<p>VOLLMER DRAINAGE IMPROVEMENTS 115 KV LAYOUT, GRADING, & DRAINAGE DETAILS TRI-STATE GENERATION & TRANSMISSION ASSOCIATION, INCORPORATED</p>	7	NO.	DATE	APPD.	REV.	M.F.
	6					
	5					
	4					
	3					
2						
1

S1150-A-01-011

ORIFICE PLATE AND TRASH RACK DETAILS AND NOTES

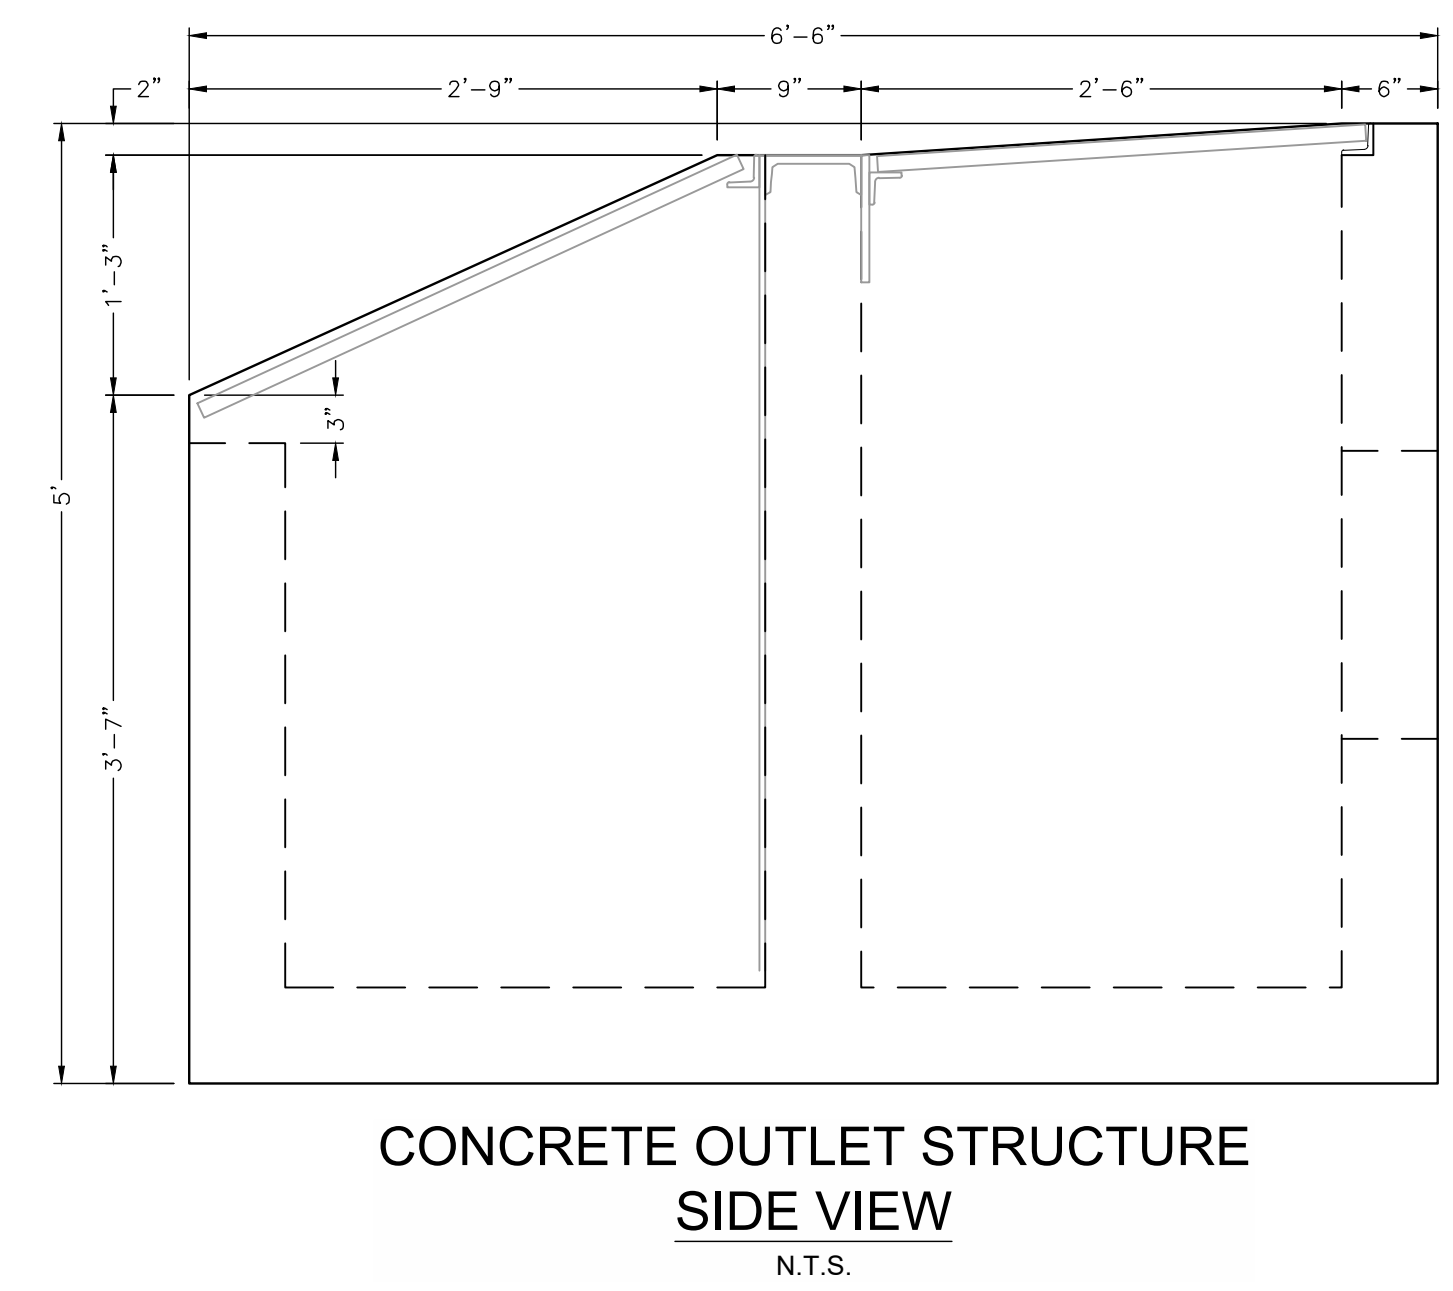
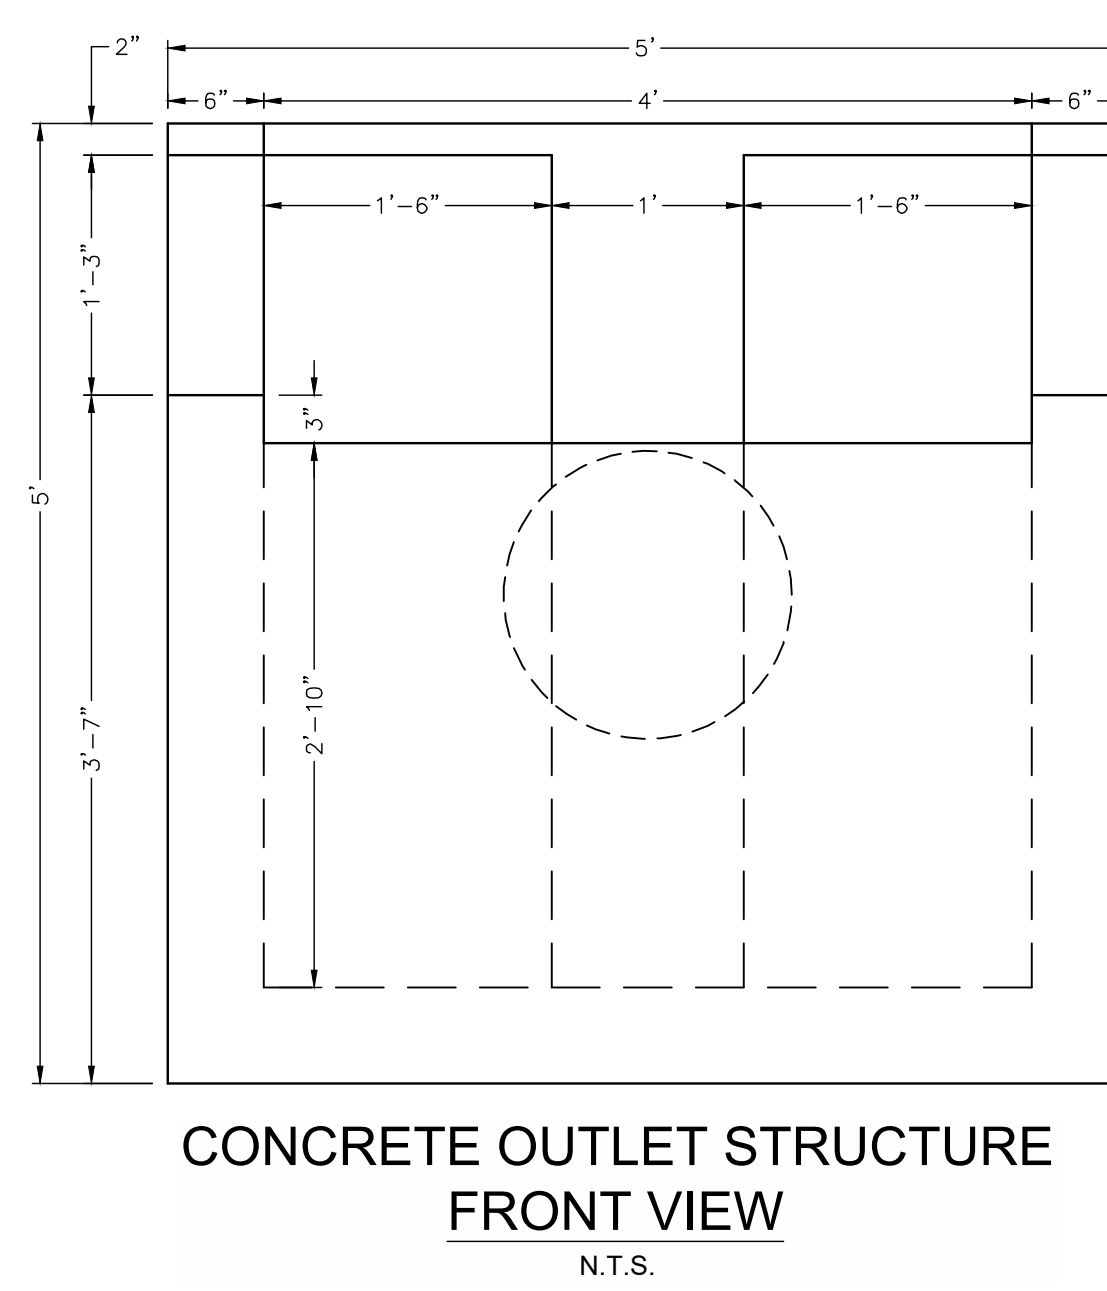
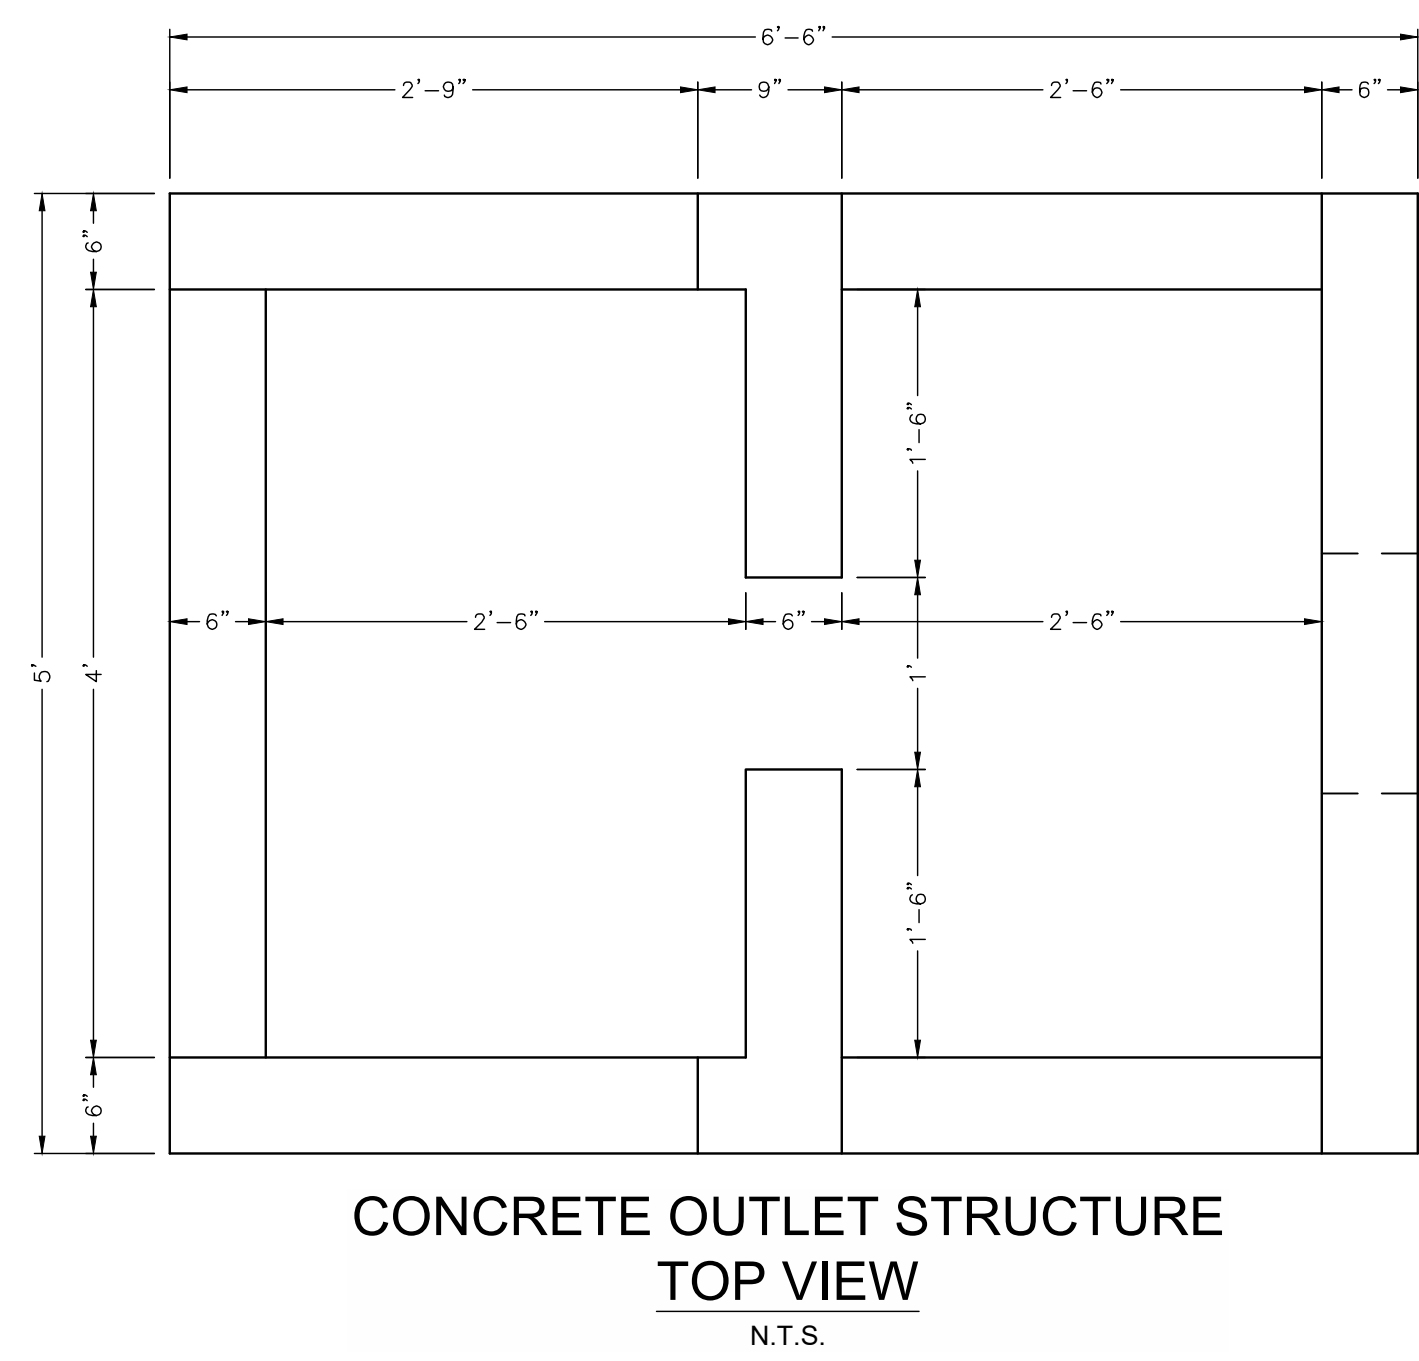
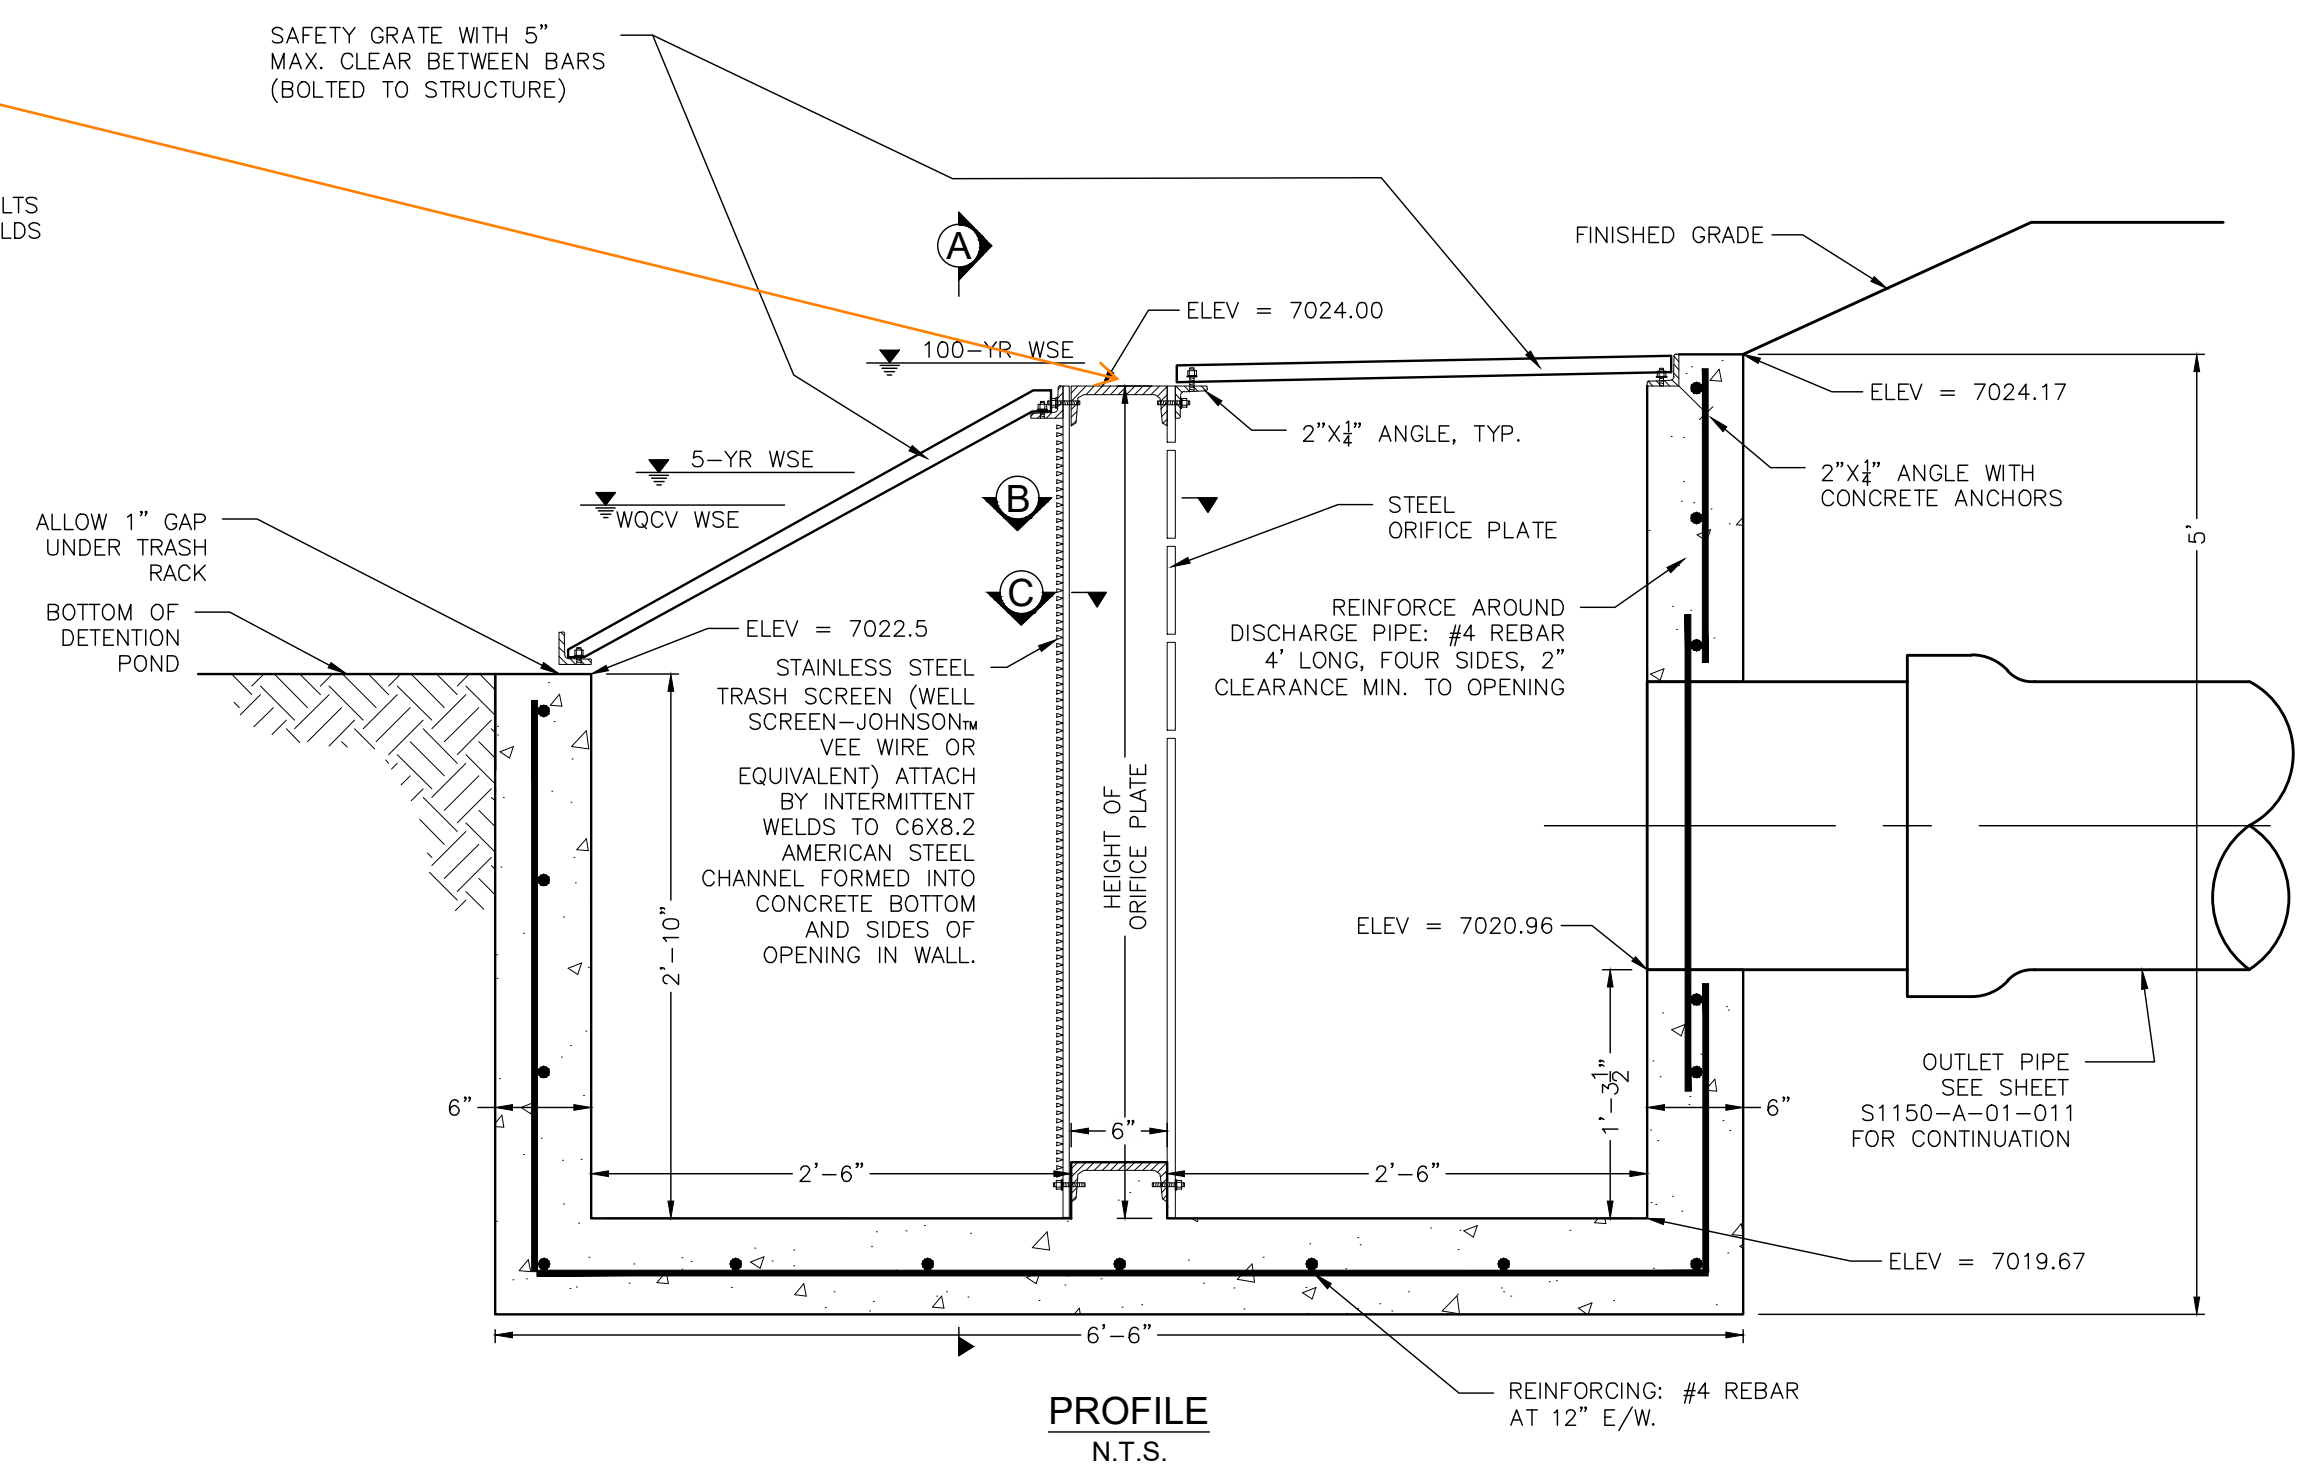
label diameter of all orifice (0.5" per calcs)

Recommend capping the top of this opening to prevent debris from getting in between microscreen and orifice plate.

Height does not match per drainage report addendum, which should be 1.5' from the reference.

per MHFD Detention calcs, the micropool WSE (ie: Stage = 0ft) should be at this orifice's centroid, not bottom.
